P. N. CYG-06-4508

Subject: Response to City of Santa Monica Review Sheet Dated August 31, 2006
Proposed Five Unit Condominium, Lot S, Block 136, Santa Monica Tract,
1327 Euclid Street, Santa Monica, California

CITY OF SANTA MONICA - GEOTECHNICAL REVIEW SHEET

Figure 1

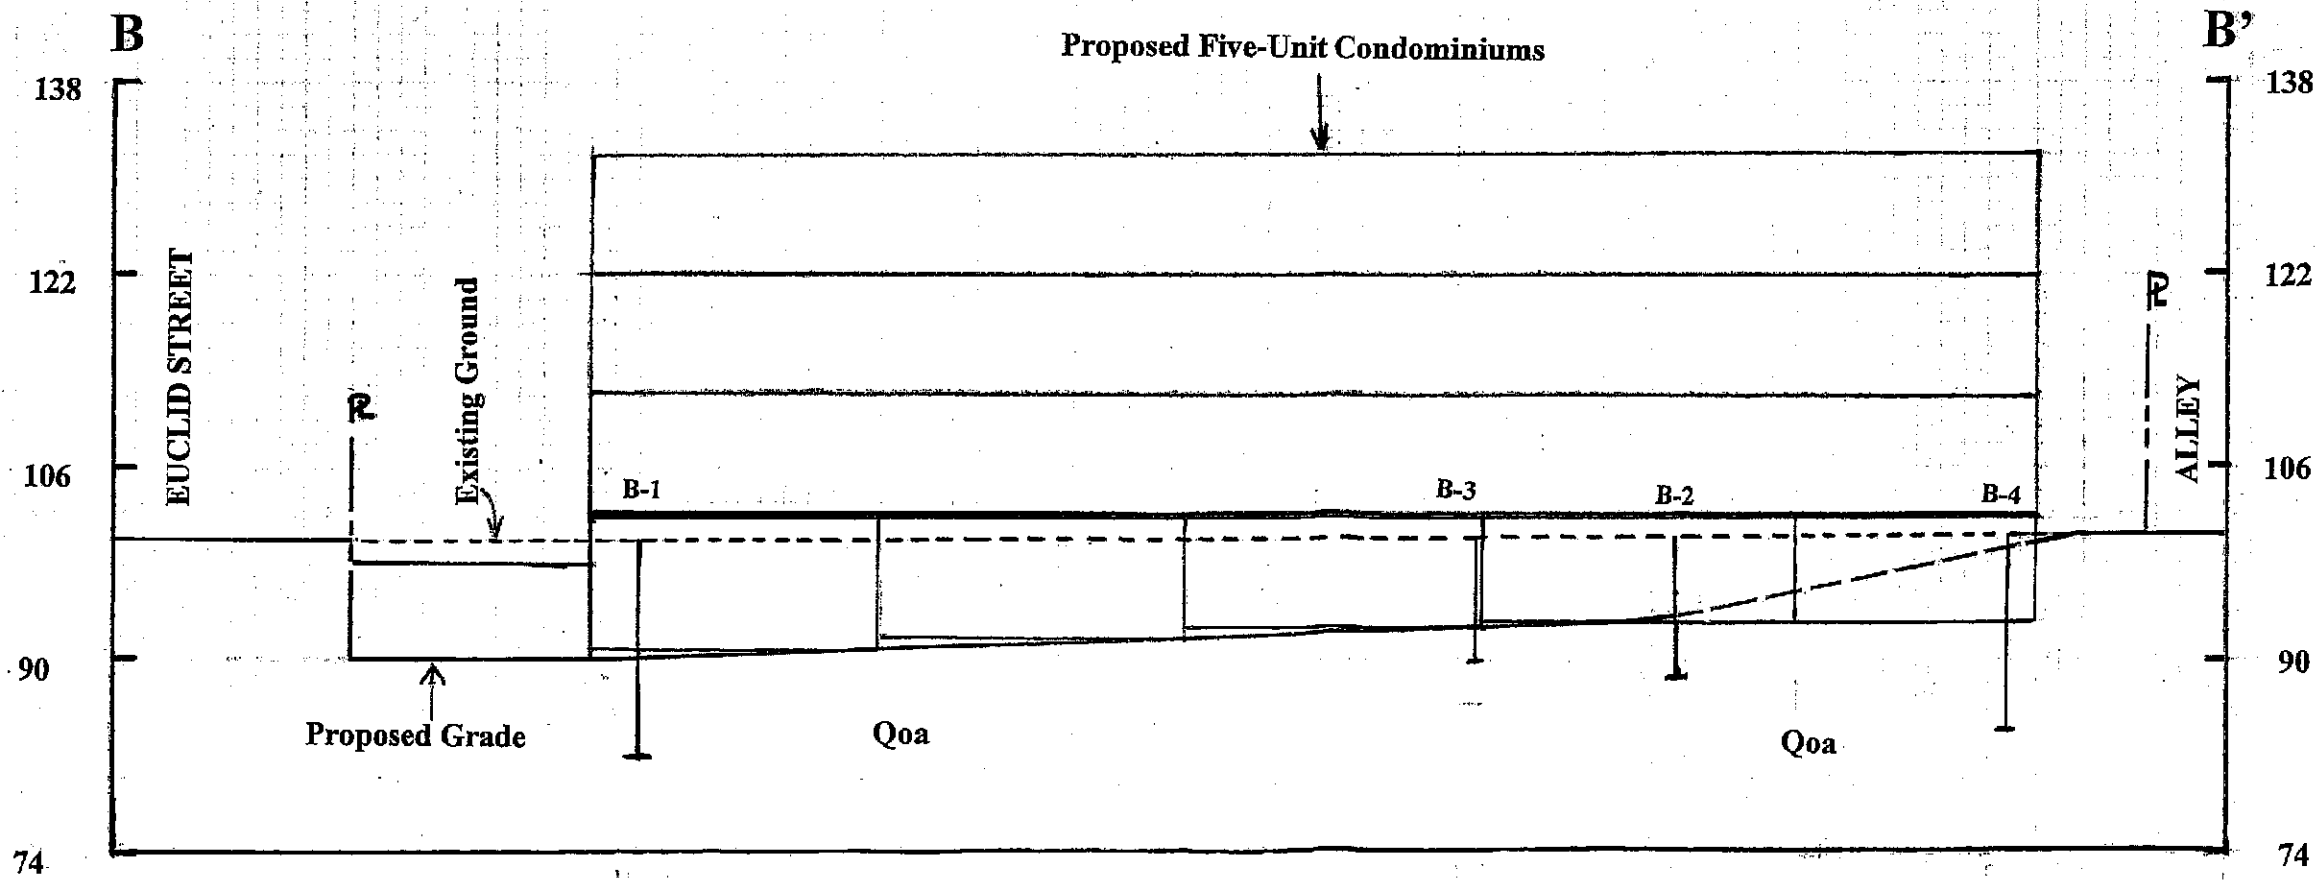
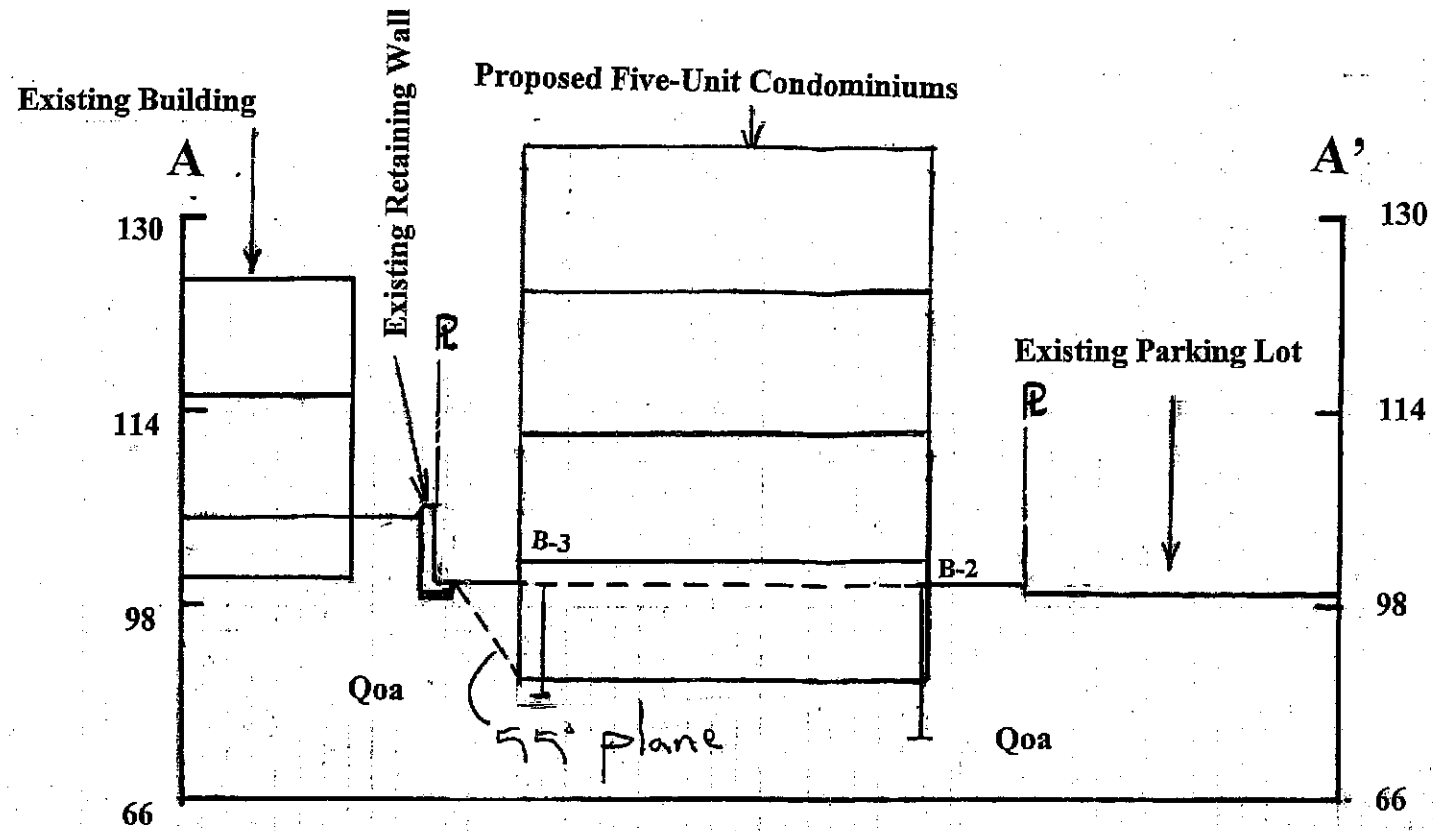
The consultant based their slot-cut analysis on the angle of the failure plane being $45+\phi/2$ (a Rankine condition). For the case of a slot-cut with resistance on the sides of the wedge, the Rankine condition may not be the most critical failure surface. The Consultant needs to perform analyses for other angles to demonstrate that either the Rankine is the most critical or some other angle is the most critical. Also, the resultant resisting force on the sides of the wedge should be taken in a direction of the inclined failure plane to be in accordance with the City's geotechnical guidelines

A computer program which can search the most critical slip surface of A/B/C slot cut as used in the calculations. The resultant resisting force on the sides of the wedge was taken in a direction of the inclined failure plane. As shown on Figure 1, no surcharge will be in the wedge which has a slip angle greater than 50 degrees. Therefore, the surcharge of 1000 and 2000 pounds per linear foot of width was applied only to the wedges with a slip angle equal to or flatter than 50 degrees. The results of the analyses are shown Figures 2, 3 and 4. The analyses indicated factors of safety greater than the minimum code requirement for all three cases.
